Scheme: Gonville Place Crossing
Cambridge

Title: Phasing of crossing
as road junction

Sheet no: 01

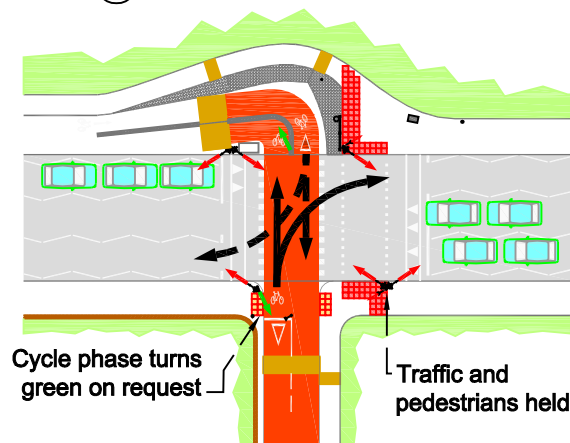
Now consider an identical layout to above, but with a ban on motor traffic using the "side road", and we have the Gonville Place crossing (below). THERE IS NO OTHER DIFFERENCE !

In order to carry out a productive trial, ensure that the following is carried out:

1. If a crossing request is made for both cycle and pedestrian crossings, allow cyclists to go first.

2. It is likely that most pedestrians will cross with the cycle phase, against a red light, rather than waiting for their own phase.
3. This will demonstrate that pedestrians are not concerned by turning cyclists and would rather mix than wait.
4. The absence of accidents will prove it is safe.
5. Conclusions: There never was any need for a turning ban.
